Proposal for Amendment 4 of the Mutual Resolution No. 1 (M.R.1) of the 1958 and the 1998 Agreements

Submitted by the Chair (Republic of Korea) of the Informal Working Group on the Deployable Pedestrian Protection Systems of UN Global Technical Regulation No. 9.

The text reproduced below was prepared by the experts of the Informal Working Group (IWG) of the Deployable Pedestrian Protection Systems (IWG-DPPS) on UN Global Technical Regulation No. 9 to amend the Addendum 5 on provisions for the DPPS Generic Vehicle (GV) Models. The modifications of the existing text of the Working Document ECE/TRANS/WP.29/GRSP/2023/7e are marked in bold for new or strikethrough for deleted characters. The modifications of _rev1 compared to GRSP-73-10e are highlighted in “blue”.

Figure 3
Components of the generic vehicle models to represent generic structure

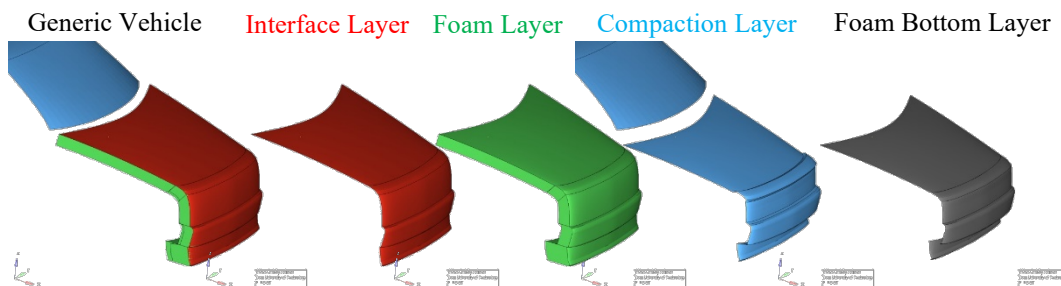
Amend as follows (move figure 3 after 3.2.1 and delete it after 3.2.2):

3.2.1. The generic vehicle model consists of the components shown in Figure 43. The structural response is modelled through an outer shell surface, an interface layer, (for modelling the vehicles fascia), a generic foam (to model energy absorbing structures like ribs), resting on the bottom layer (a rigid skeletal vehicle structure) and the compaction layer which works a hard stop.

Figure 4
Impact locations for ~~GV certification~~ **plausibility check**

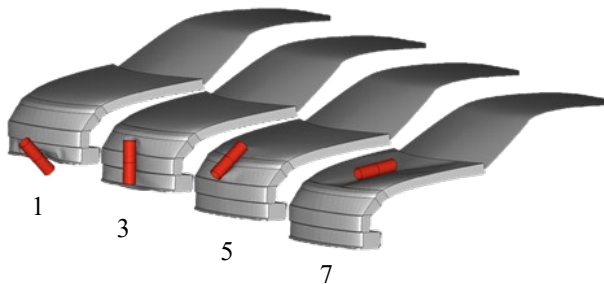
- 4.1. ~~The certification of~~ **Impactor simulations on** the generic vehicle models may be performed if the user has any doubt that the generic vehicle models work properly with the solver version and control cards used **as plausibility check**. If issues (i.e. ~~significant~~ **the** deviations to the reference curves **outside of the** provided **corridors shown in red**) are identified, the user shall switch to another solver version **[and]** review the control settings ~~[and report the issue to gv.vsi@tugraz.at~~ **GRSP through a Contracting Party**].

- 4.2. To perform the comparison, the files specified in Annex 2 for the respective FE code, vehicle shape and impactor location shall be used. Impacts shall be performed with the rigid cylindrical impactor (density= 7.89 E-6 kg/mm³, diameter= 120 mm, height= 400 mm and wall thickness= 5 mm) at the vehicle centreline on the spoiler (ID=1), Bumper (ID=3), Bonnet Leading Edge (ID=5) and bonnet (ID=7), as shown in the figure below.
